INDIANA MICHIGAN POWER COMPANY

DONALD C. COOK NUCLEAR PLANT, UNIT NO. 2

AMENDMENT TO FACILITY OPERATING LICENSE

Amendment No. 108
License No. DPR-74

FIGURE 3.1-3 REQUIRED SHUTDOWN MARGIN

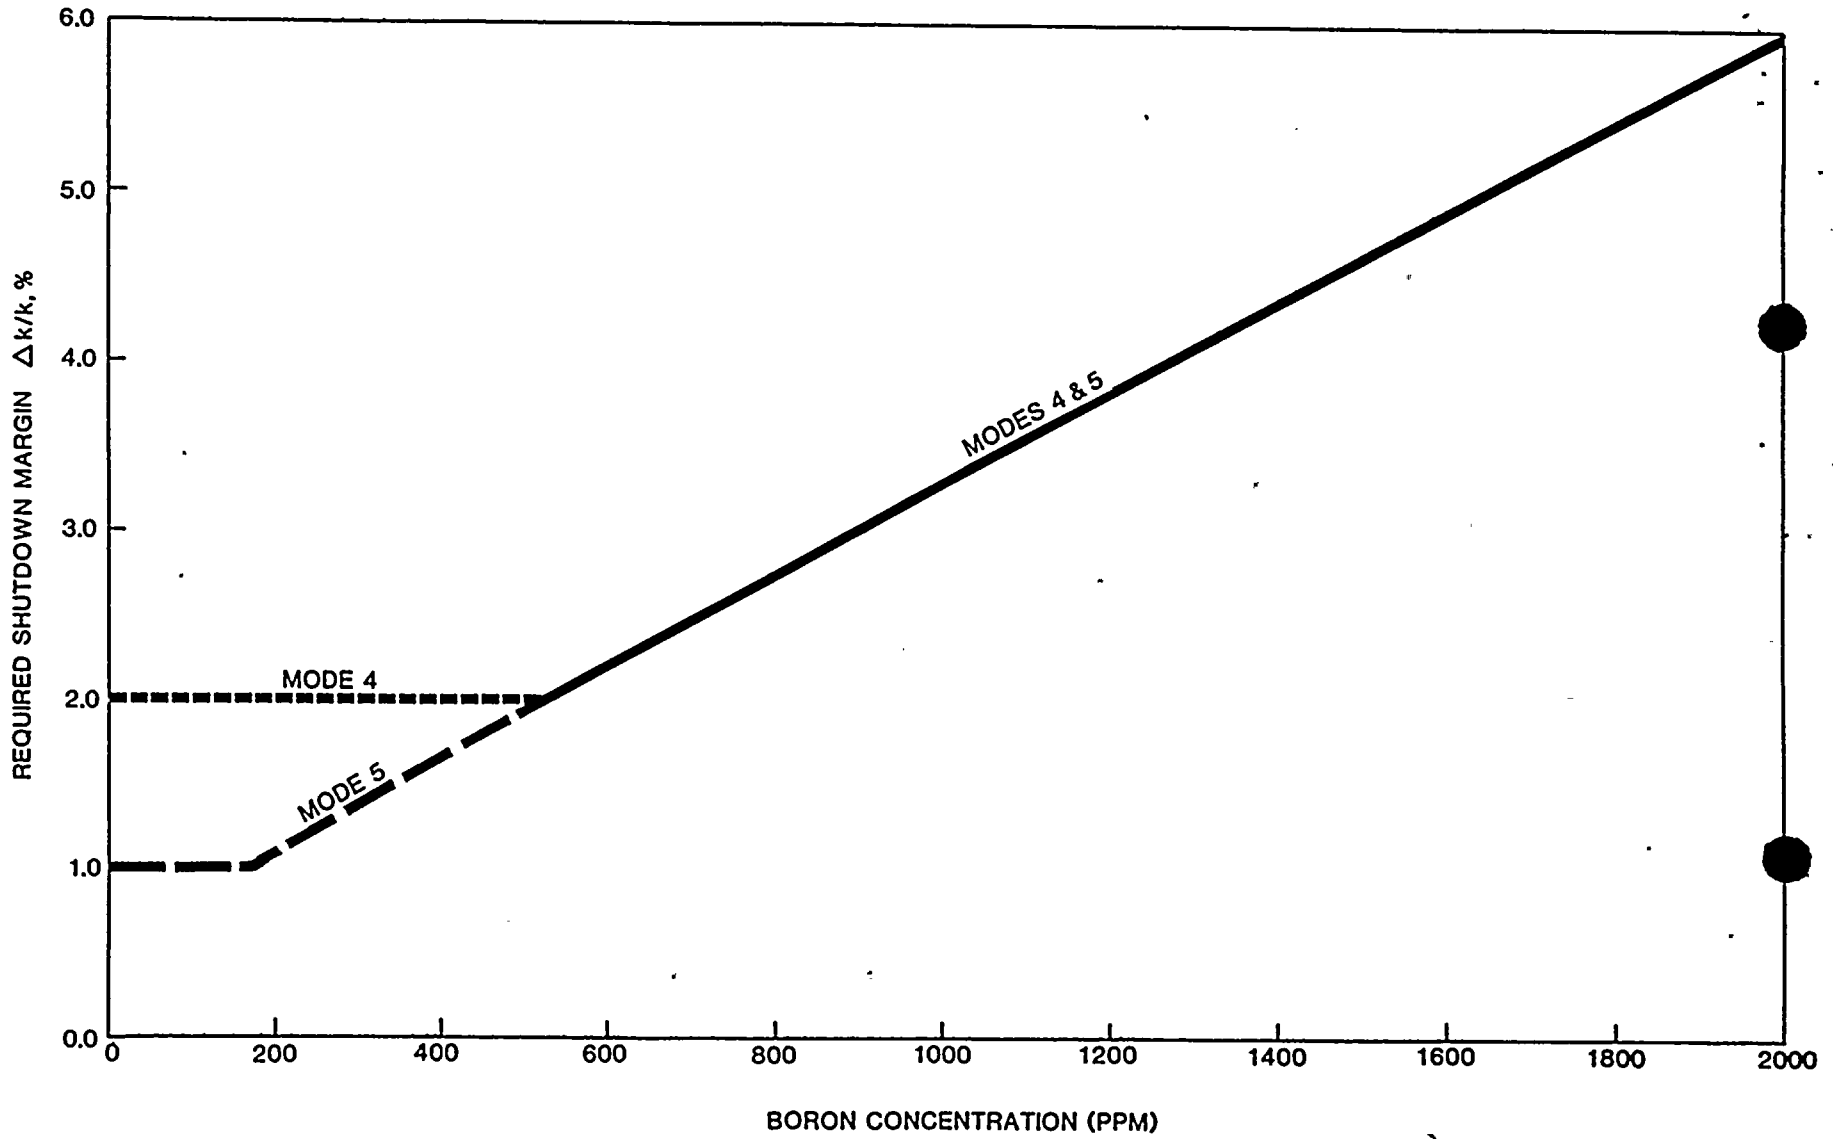
1. Greater than or equal to 2.0% $\Delta k/k$ when operating with one or more Reactor Coolant Loops in accordance with Specification 3.4.1.3.
2. Greater than the value shown in Figure 3.1-3 when operating with no Reactor Coolant Loops but one or more Residual Heat Removal Loops in accordance with Specification 3.4.1.3.

1. Greater than or equal to 1.0% $\Delta k/k$ when operating with one or more Reactor Coolant Loops in accordance with Specification 3.4.1.3.
2. Greater than the value shown in Figure 3.1-3 when operating with no Reactor Coolant Loops but one or more Residual Heat Removal Loops in accordance with Specification 3.4.1.3.

In shutdown MODES 4 and 5 when heat removal is provided by the residual heat removal system, active reactor coolant system volume may be reduced. Increased SHUTDOWN MARGIN requirements when operating under these conditions is provided for high reactor coolant system boron concentrations to ensure sufficient time for operator response in the event of a boron dilution transient.
